**BOARD OF ADJUSTMENT MEETING  
CITY OF ST. PETE BEACH  
COMMISSION CHAMBERS**

**a. Case No. 25055 – 2311 Pass-a-Grille Way**

**b. Case No. 25052 – 100 Pass-a-Grille Way**

Figure 4: Elevation drawing showing variance requested

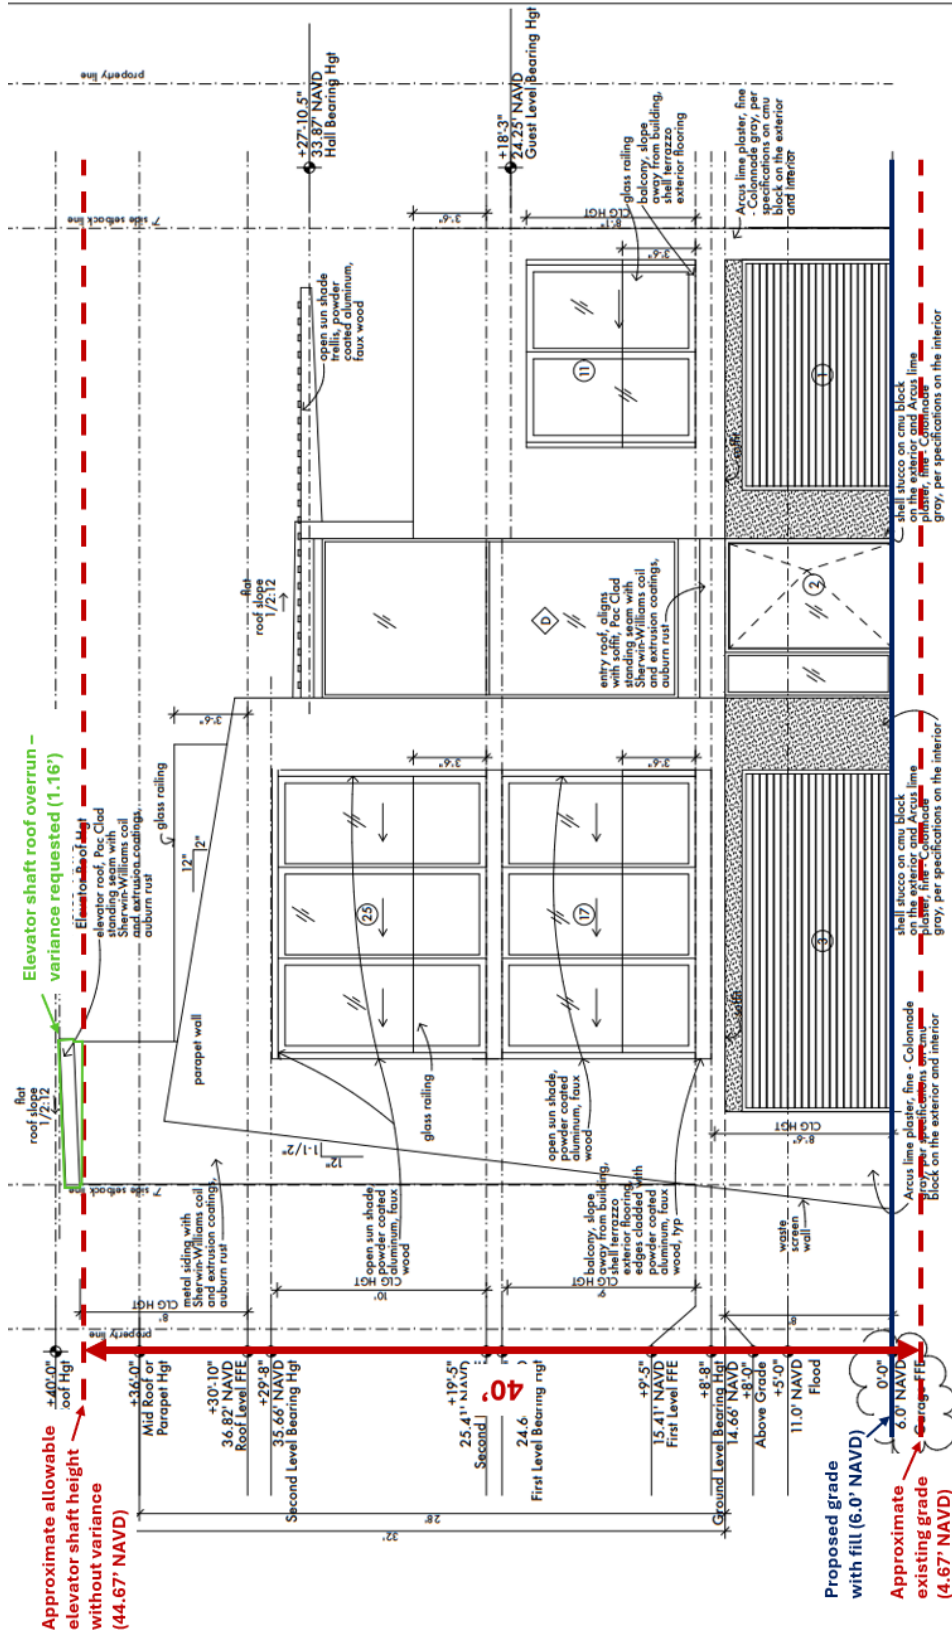
measures 39.83 feet above newly-established grade to the top of its highest appurtenance, an elevator shaft enclosure, exceeds allowable height for this enclosure by 1.16 feet due to this grade change. The height to the parapet of the occupiable roof, which is limited to 28 feet in height as described above, remains compliant with the height limitation despite the fill.

*Staff does not find the request to be adverse to the comprehensive plan or Land Development Code, but finds the issue to become a potential recurring issue for others in the vicinity who undertake seawall replacement prior to new construction.. Staff generally finds that the grading of the lot relative to the height of the seawall, and the overall height of the structure relative to the lot's proposed grade, is generally in keeping with the intent of the height regulations. The applicant is not ultimately seeking a taller home relative to established grade than they would have been able to build without filling the lot, and the amount of fill introduced appears to be logical for the seawall height constructed.*

Figure 4: Site Layout Plan (N.T.S.)

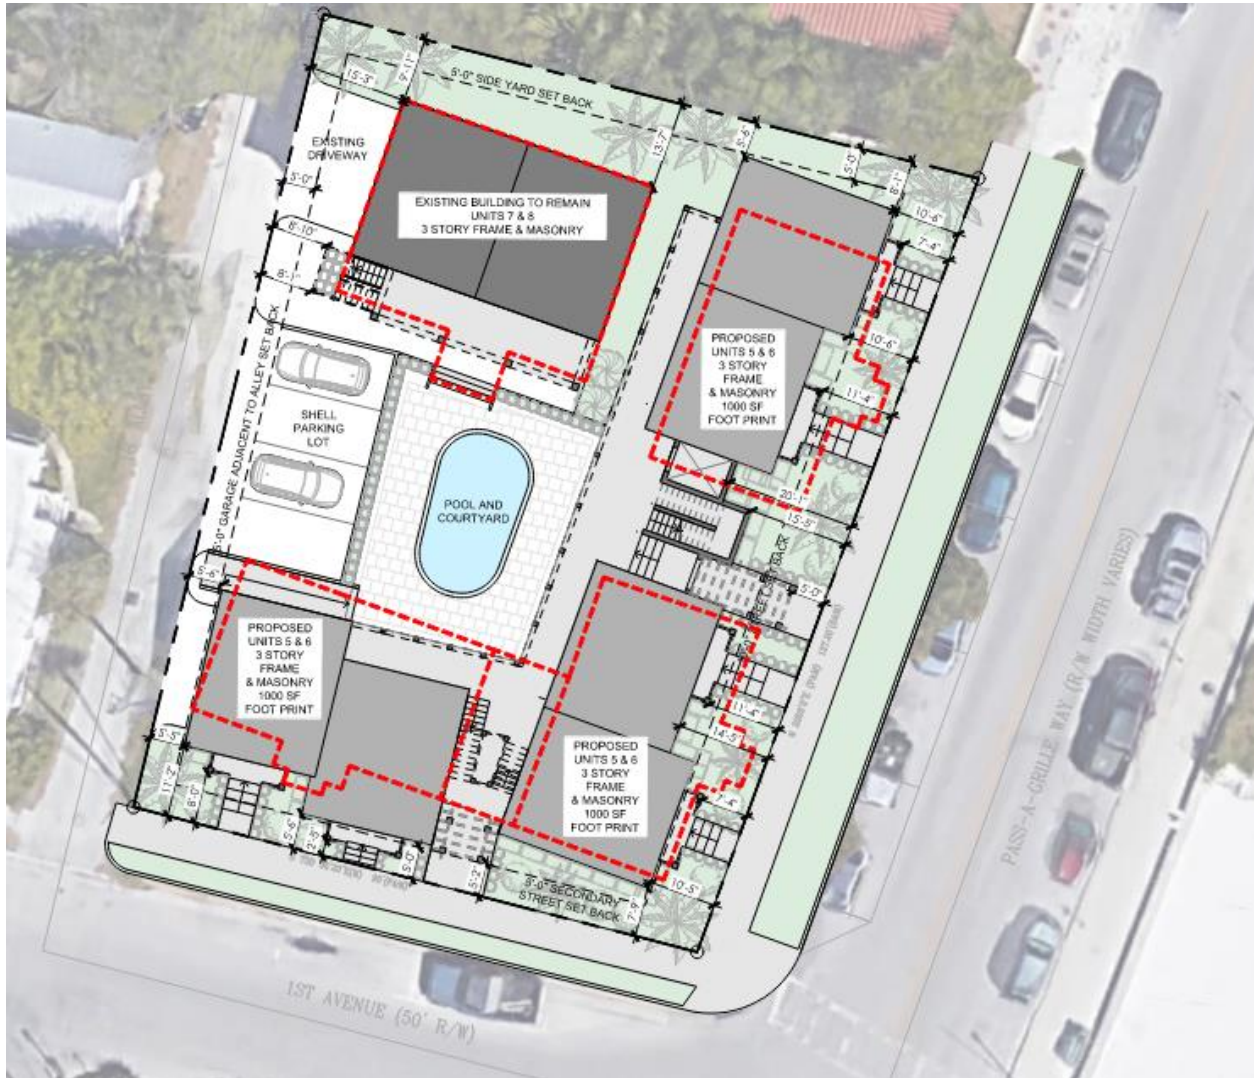
*The request for encroachment of the porch on the southern frontage of the lot appears to largely be undertaken to accommodate a new pool at the center of the property, and does not reflect an existing condition. Staff does not find the southern porch encroachment to be based upon response to an existing peculiarity of the land, structure, or building, but one created through this project to accommodate an accessory feature.*

*Staff does find support for this request for the setback encroachment of the Units 1 & 2 building independent of the additional living area request, and encroachment of the balconies into the eastern frontage and rebuilt stairs into the western alleyway frontage. The applicant's reconstruction of these dwelling units is not being undertaken voluntarily but as a response to the damage sustained to the structures, and the applicant is required to both elevate the structures and comply with current parking requirements. Other property owners in Pass-A-Grille have the option to maintain their existing nonconforming setbacks and parking conditions, which is not available to the applicant in this instance due to the extent of damage to the two eastern structures as relayed by the City's inspector.*

1. The interior ground-floor developed square footage provided under this request shall not exceed the footprint of the living level above, or 450 square feet, whichever is larger.
2. The façade features, footprints, scale, massing, attached accessory features, and general color schemes of the primary structures as presented in renderings and floor plans attached to this request shall be preserved, except that minimal alteration may be made as necessary to comply with conditions or approvals of these variances, or requirements of the Florida Building or National Fire Prevention Code. Any alteration deemed significant to the City Manager shall require this request to return to the Board of Adjustment for reconsideration.
3. The rooftop decking shall remain an accessory space to the dwelling and no commercial activities may be utilized or approved on the rooftop.

Figure 5: Floor Area Calculations

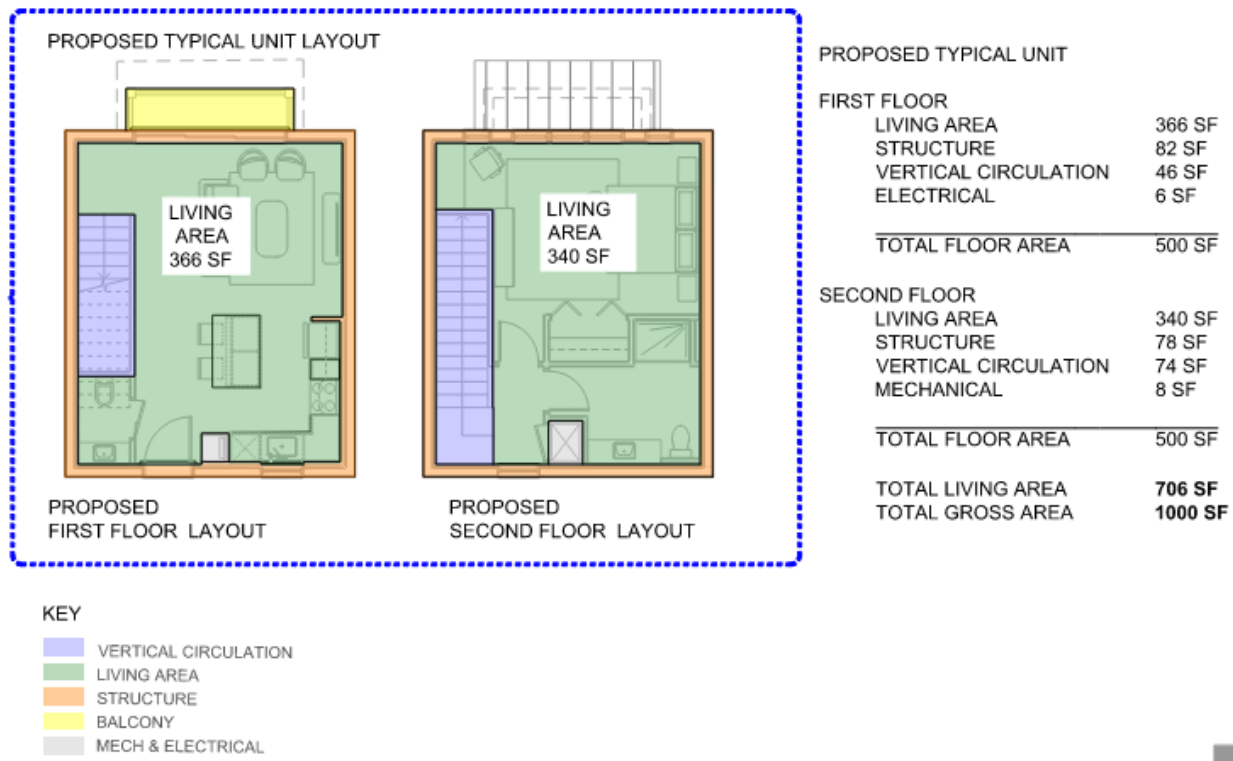
*The variance allowing for additional developed square footage, particularly the additional living level and associated living square footage, is likely to lead to greater financial viability for the project. However, Staff has reviewed the floor plans submitted on May 14<sup>th</sup> and finds that the spaces proposed within each unit are reasonably-allocated, with the project comprising only approximately 706 square feet of living space between walls independent of the stairs, landing, electrical area, and mechanical closet. Floor space is to be utilized for an open-floor plan living area and kitchen on the ground level,*

*the structure by at least eight feet mandatory, with the minimum living level elevation above grade likely to be 9-10 feet due to coastal zone requirements. Requiring this elevation without allowing the applicant to utilize the newly-established ground level as usable, non-habitable, space would present a significant hardship to redevelopment and likely render it impossible to preserve the existing form, mass, and square footage of the living level of the building. Staff also finds the applicant is not at fault for complying with Fair Housing Act requirements, and finds the request for an additional 22 square feet to place a powder room at the ground floor to be reasonable.*

PROPOSED TYPICAL UNIT LAYOUT

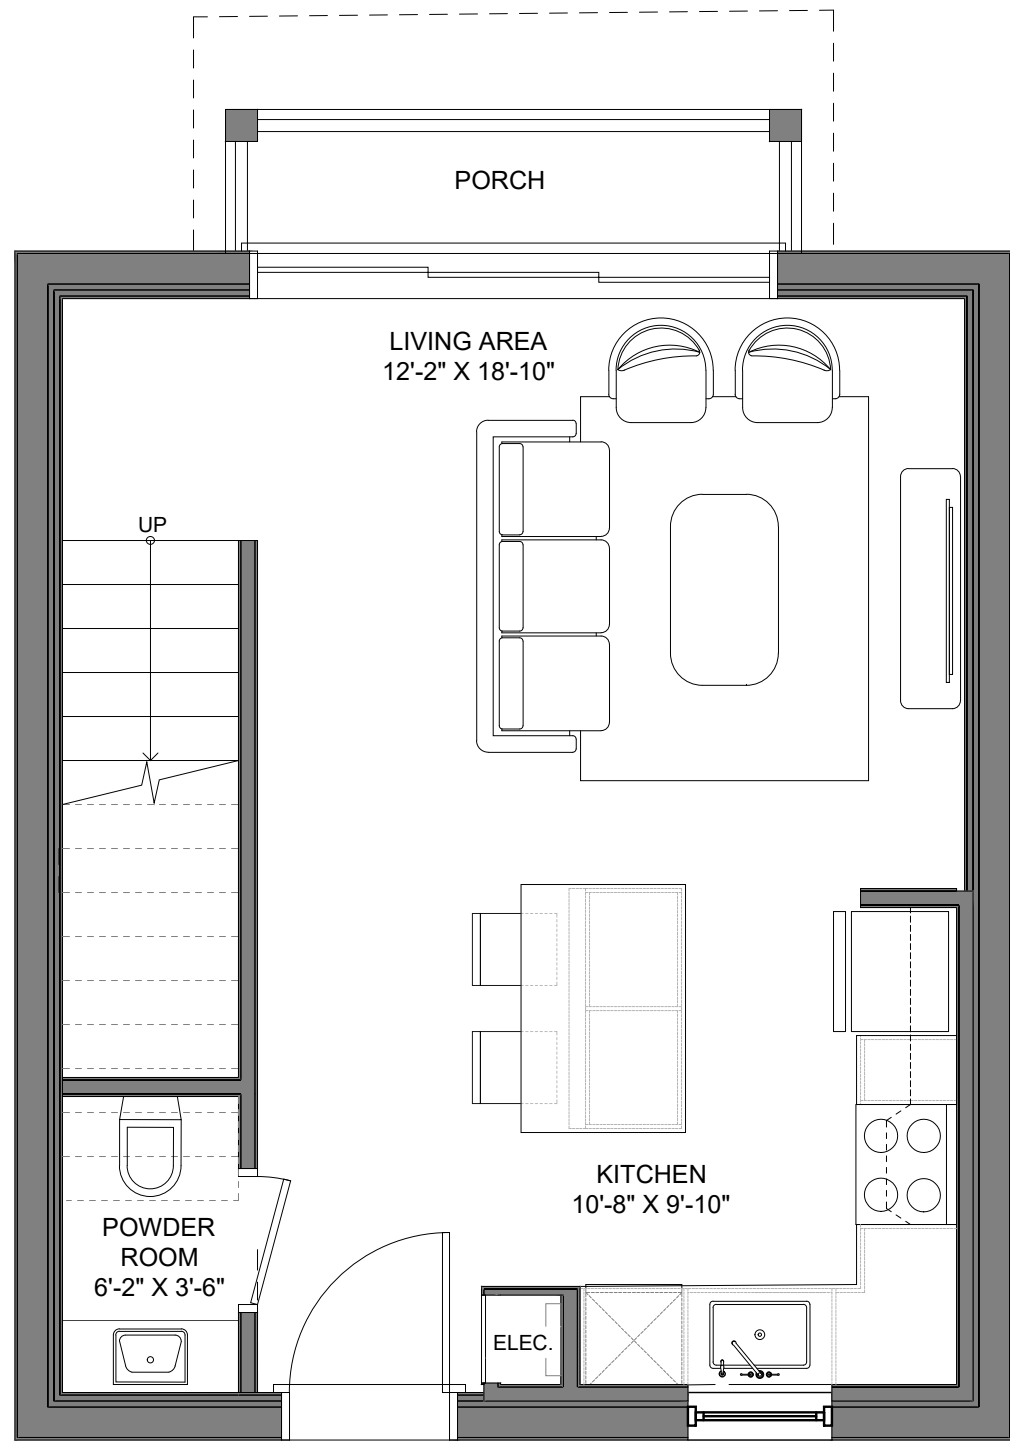
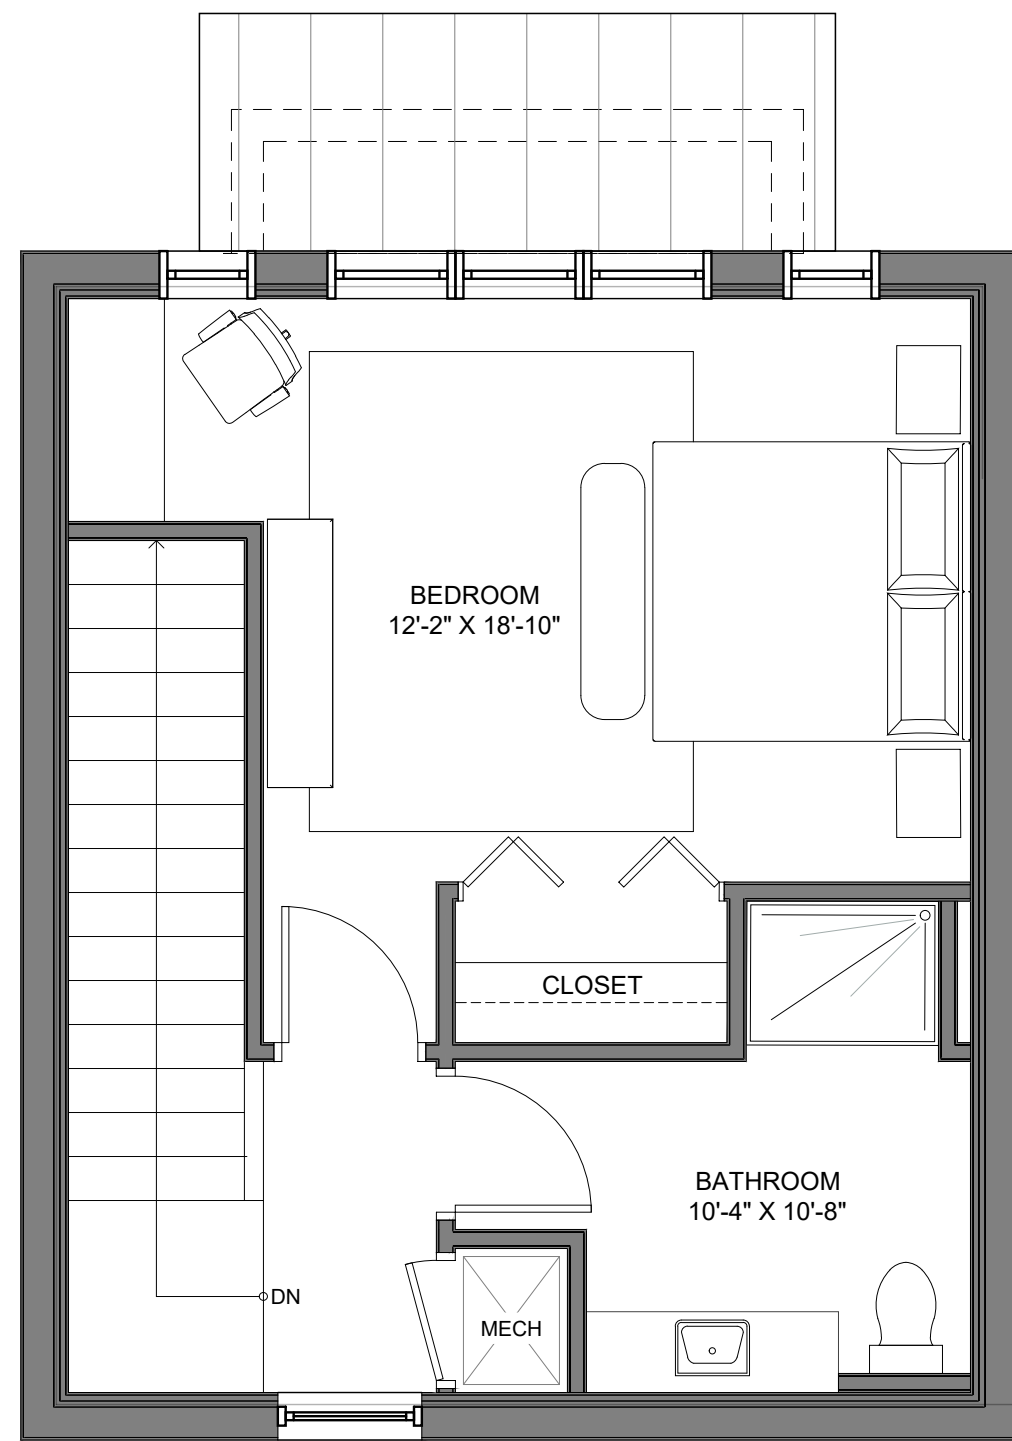
8. Staff recommends showing room layout on the floor plan if helpful to justify the statements made in the variance application responses 5, 7 and 8 to support the need for additional living square footage.
